Re: **PETITION NO. 1189** – The United Illuminating Company Petition for a Declaratory Ruling That No Certificate of Environmental Compatibility and Public Need is Required for the Proposed Modifications to the Existing Mix Avenue Substation Located at 690 Mix Avenue, Hamden, Connecticut and Related Improvements to Existing Electric Transmission Line Circuits From Mix Avenue Substation to Glen Lake Junction and From June Street Substation To Pease Road.

Please find enclosed the original and fifteen (15) copies of The United Illuminating Company's ("UI") responses to the Siting Council's First Set of Interrogatories, dated September 29, 2015 in connection with the above-referenced Petition. Additionally, UI will electronically file all responses and attachments via siting.council@ct.gov.

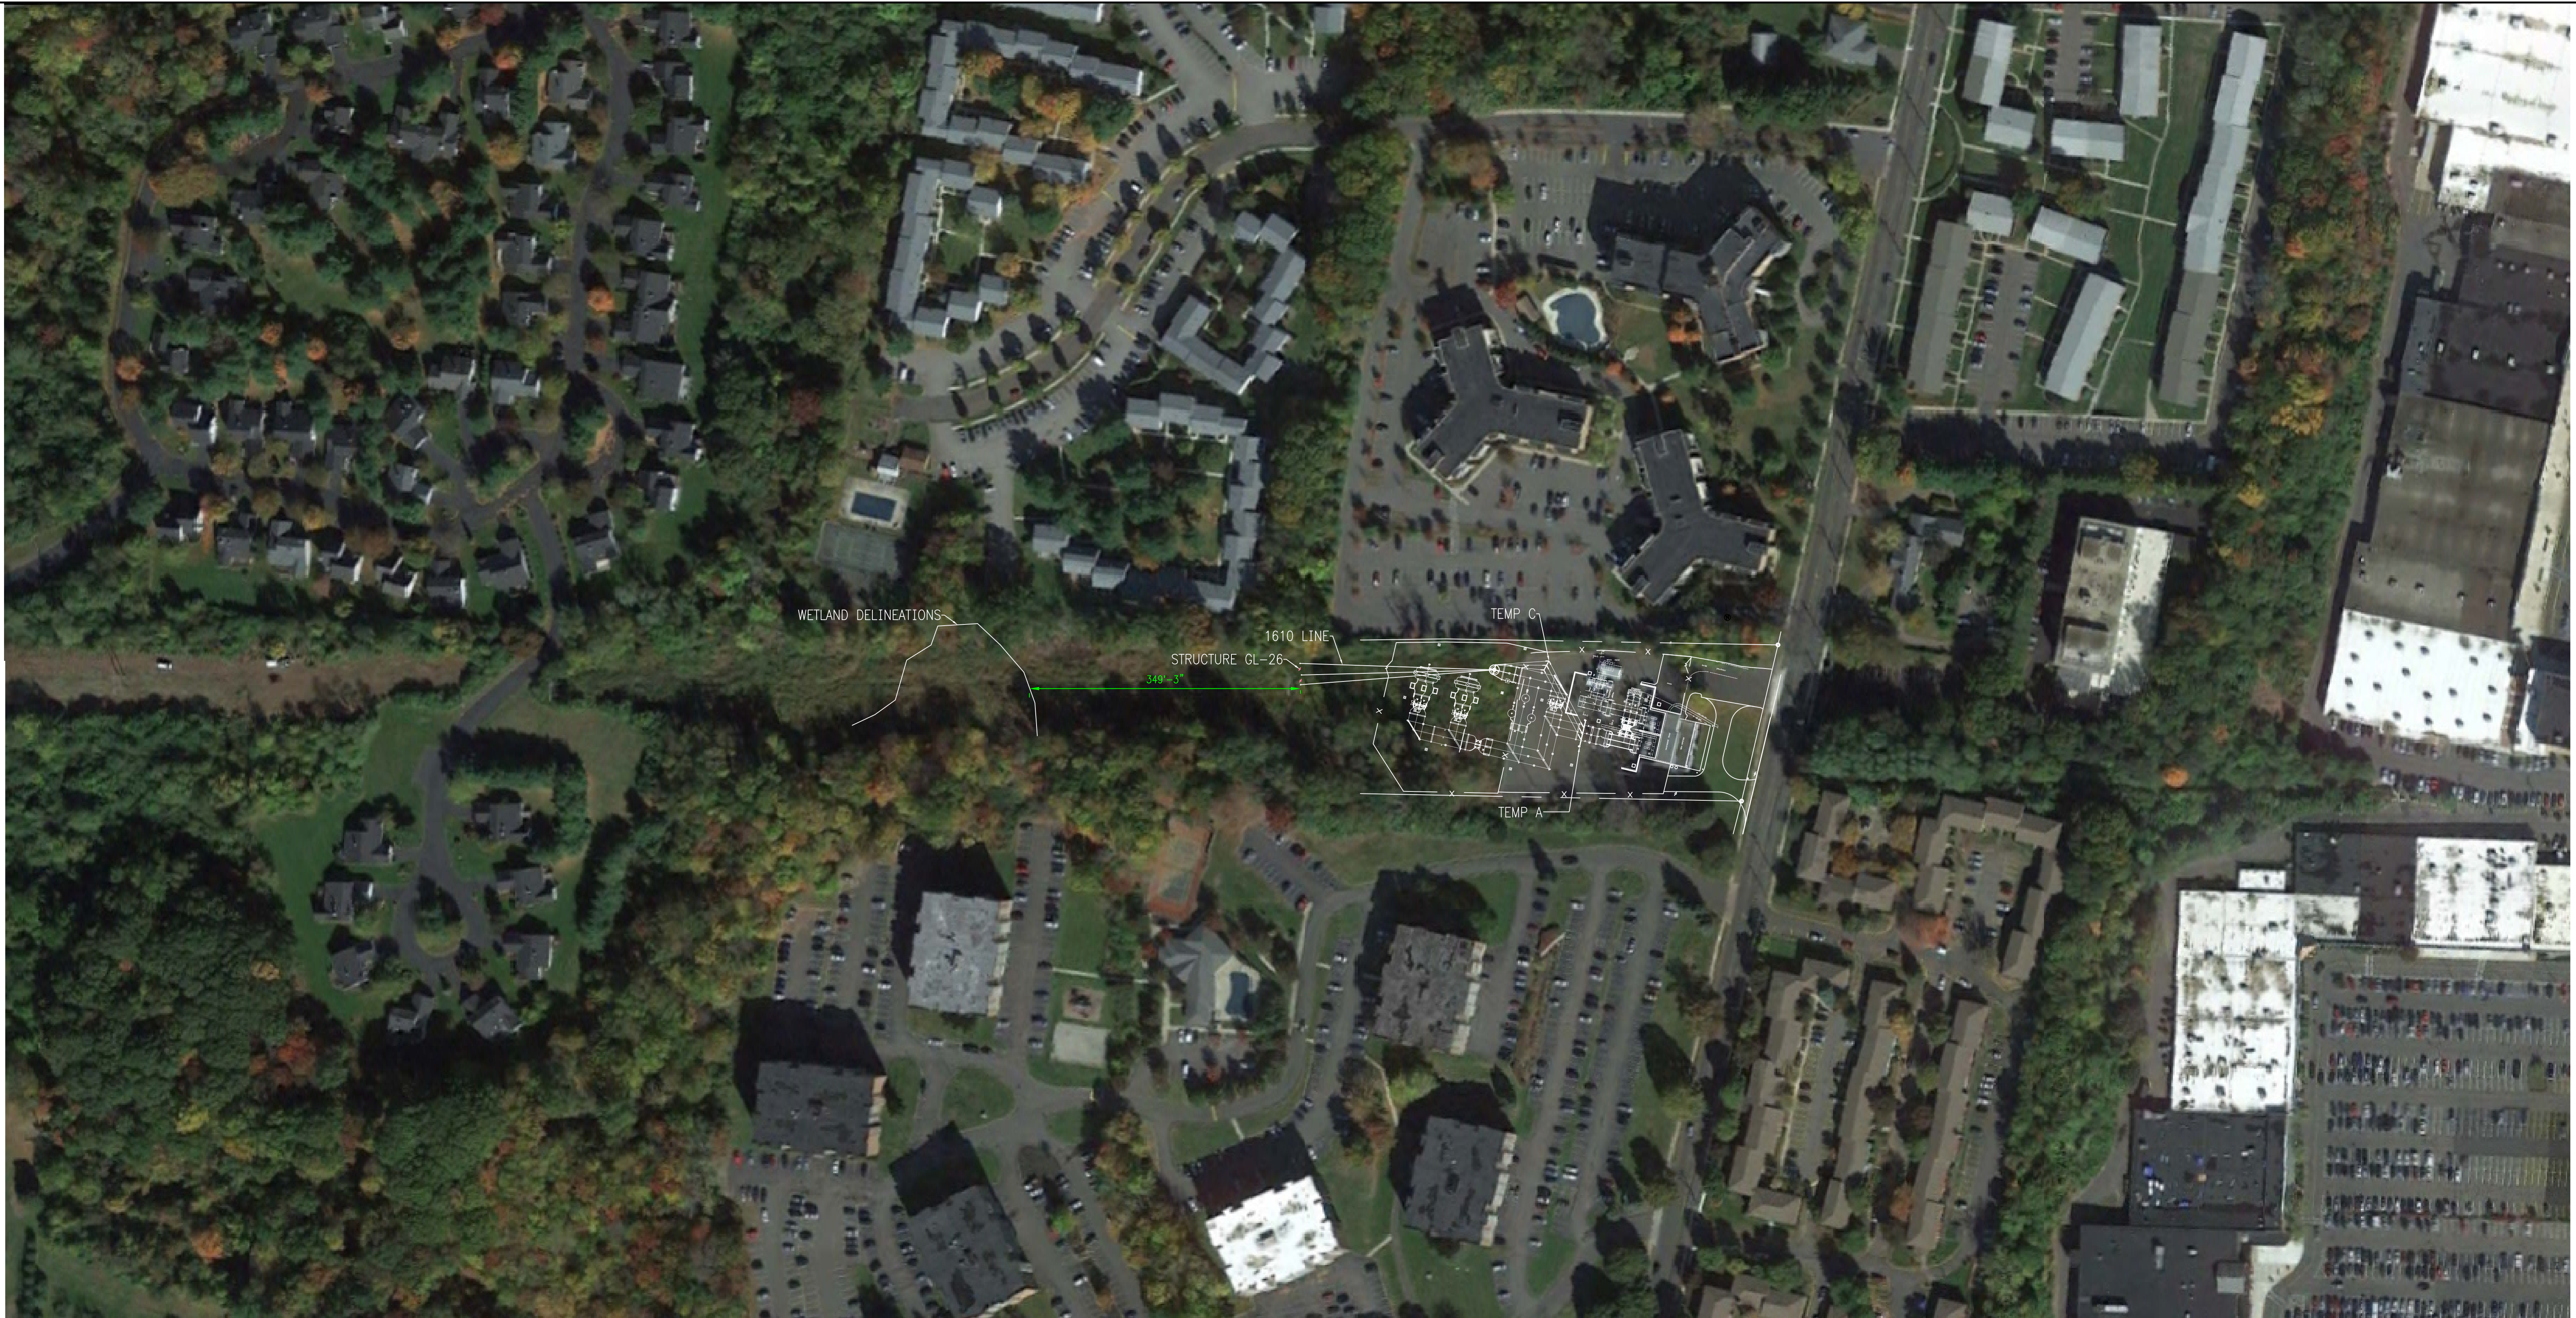
Q-CSC-3: Provide a drawing or map indicating the proposed locations of the three temporary wood transmission structures and the two #1610 line transmission structures to be replaced/relocated.

- Install new structure GL27 and remove existing structure GL 27
- Install temporary structure C
- Transfer conductors to new GL 27, structure C
- Remove temporary structure A

A-CSC-3: New permanent structure 26 is a wood 3-pole Pole arm Dead End with steel cross-arms and wood cross-braces. The poles are 75' tall embedded 10% + 2' in the ground, for a height of 65.5' above ground.

New permanent structure 27 is a steel monopole, 65' tall on a concrete drilled pier foundation. Its phases walk down the structure before spanning back to the substation bus.

Please see PE1189 A-CSC-3_Temporary Wood Transmission Poles.
